22 August 2014 Lend Lease Building Pty. Ltd. Level 4, 30 The Bond 30 Hickson Road Millers Point NSW 2000

Subject: Wind Engineering – Barangaroo South Building R7

Ref: (1) CPP report, Barangaroo Masterplan, dated December 2013

Figure 1: Ground floor plan (T), north elevation (BL), west elevation (BR) of the proposed Barangaroo South R7 development

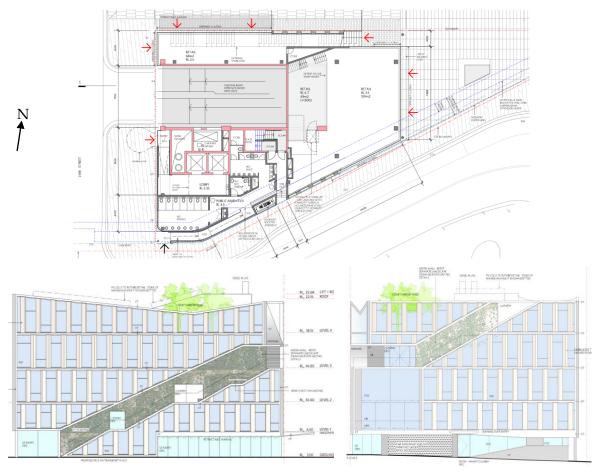
Please find herein comments regarding the impact of Barangaroo South Building R7 and the pedestrian level wind conditions. The architectural drawings prepared for this application, Figure 1, have been reviewed and assessed from an environmental wind perspective at ground level. Compared with the massing model used for the wind tunnel testing of the Barangaroo South precinct, Figure 2, the architectural form of the building has been developed, but the general massing of the building has remained similar. The details of the wind-tunnel testing and analysis are contained in Reference (1).

In summary, it is expected that the design of Barangaroo South Building R7 will not change the local wind conditions from those measured with the massing model used in the wind-tunnel testing. All ground level locations are expected to meet the 'pedestrian walking' comfort criterion and pass the distress criterion.

Figure 3: Wind climate results from December 2013 report

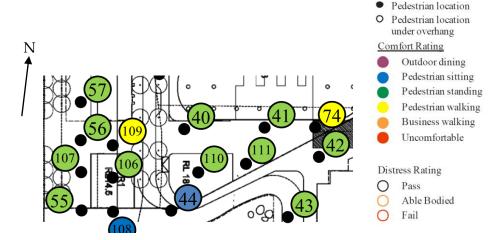
The directional wind flow pattern around the site is complex. The classification of wind conditions at various locations around the site is summarised in Figure 3, with directional results presented in Figure 4 and Figure 5; the contours relate to the wind climate at the site, and the distance of the symbol from the centre of the plot represents the local mean wind speed for winds from that direction. Classification of the comfort and distress criteria is determined by the integration of the measured wind speed with the local wind climate as discussed fully in Reference (1).

The wind flow in this section of the Barangaroo South precinct is dictated by the neighbouring taller structures and the open harbour to the west. From a pedestrian comfort perspective the wind conditions around the site all met the pedestrian walking criterion, with the majority of locations being classified as acceptable for pedestrian standing activities, Figure 3. All locations passed the distress criterion. The wind conditions around the amended geometry would be expected to be similar to those measured.

It is evident from Figure 4 and Figure 5 that strong wind events tend to occur for winds from the south and north-west quadrants and are caused by the proximity of R7 to Building C5, which is exposed to southerly winds, and the open nature of the harbour to the west. The wind conditions in the open space area to the east of R7, Location 111 in Figure 3, would be suitable for café style activities for about 85% of the time, and for

outdoor dining for 60% of the time. As the wind conditions in this area are governed by the taller building massing, to improve the wind conditions around the building local amelioration techniques such as vertical screening would be required.
